**Louisville - Southern Indiana Ohio River Bridges Project
Kentucky Historic Preservation Advisory Team
Meeting – March 29, 2007, 10 am – 4pm
CTS-GEC Conference Room**

KHPAT Meeting

KENNEDY INTERCHANGE

March 29, 2007

3' Barrier with Rail

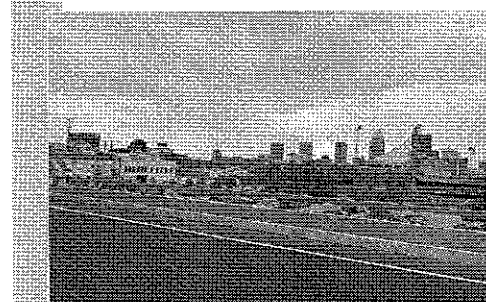
Mr. Sutherland informed the KHPAT that following much study, the decision to use full concrete barriers was endorsed by the BSMT as opposed to the open side rail design that had been forwarded by the KHPAT. The decision had been made based on the substantially increased cost of the open rail design and the increased need for and difficulties of maintenance of the rail design. Ms. Barras stated concrete barriers imposed adverse visuals for drivers; Ms. Copic echoed that the City had been strongly in favor of the rail design due to the location. Responding to questions, KYTC indicated that the concrete barriers are more sturdy than the rails and therefore need lower levels of maintenance and that the difference between the full concrete and open side rail design would be about 10 or 12 inches of concrete. Ms. Barras maintained that the concrete barriers were not context sensitive design.

Mr. Nouri stated no public input on the rail selection and concrete barriers had been solicited. He also noted the concrete barriers were not in accordance with Miguel Rosales recommendations in the Aesthetic Design Guidelines (ADG). Mr. Bart Bryant stated that public input had occurred thru the Area Advisory Team (AAT), Regional Advisory Committee (RAC), and Historic Preservation Advisory Teams (HPATs).

[MOTION] Ms. Barras made a motion that recommended that one or more of the concurring parties invoke the dispute resolution mechanisms of the MOA to enter dispute resolution on the side rail issue. Mr. Segrest seconded the motion. Four KHPAT members votes yes and one vote abstained. As previously described, if this is what the concurring signatories want to do, a letter must be written to FHWA by April 30, 2007 to invoke dispute resolution.

- The initial concept evaluated was to use concrete open-rail barriers everywhere, including locations where guardrail would normally be used
- The project team has evaluated the cost of open railings vs. traditional solid barriers
- The cost differential was approximately \$8 million
- Due to fiscal constraints and long-term maintenance considerations, guardrail and solid bridge rails will be utilized

Roadway Luminaire - Option 2

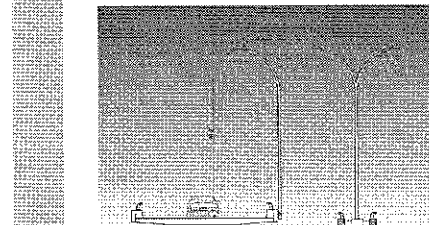
Following this motion, options for interstate lighting and signage were presented. Mr. Sutherland stated that for the lighting, the KHPAT had recommended option 2 and that was also the option being recommended by KTA. Final details of specific type and color are still pending. Next Mr. Sutherland noted that the HPAT had recommended option 2 for signage and that this was again going to be the option recommended by KTA.

- Metro is on record in support of Option 2
- Ratio Architects support Option 2 as being most compatible with historic context
- KTA supports Option 2 as the most cost-effective option
- KTA will formally request approval from BSMT to go forward with Option 2 for both sign and light supports

Status

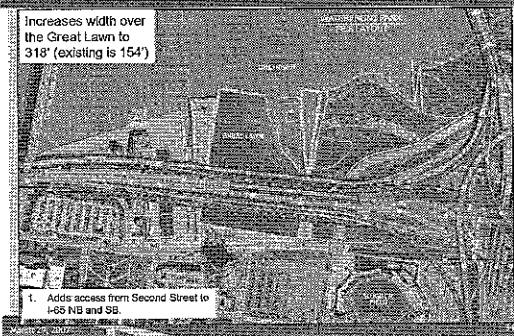
In reference to noise studies, Mr. Sutherland stated that nine sites were evaluated for the construction of noise barriers. At this point, only one section of noise wall was under final consideration as feasible. This final location is section 7, east of I-64, as shown on slide #32 of the presentation. Mr. Sutherland also stated that in the near future, SDC would coordinate the location of this possible wall with the Clifton neighborhood.

- Currently, one wall site is under final consideration (Section 7, east of I-64)
- Community will have opportunity to comment on wall desirability
- BSMT will make final decision on if and what types will be constructed

Layout 5 - M

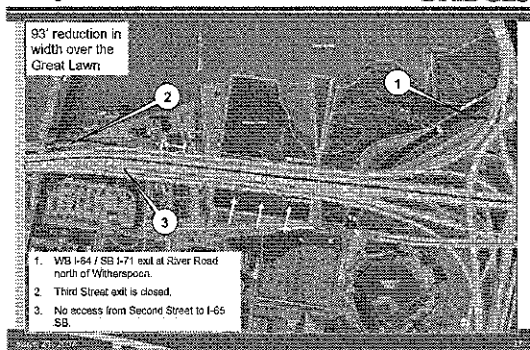
In regard to the construction of a new bridge over the Great Lawn in Waterfront Park, Mr. Sutherland stated that the number of piers had been reduced to minimize encroachment upon the Park. Two rows of piers are proposed that are approximately 300 feet apart.

- The BSMT has approved Option 5-M
- KTA will develop design plans for this option
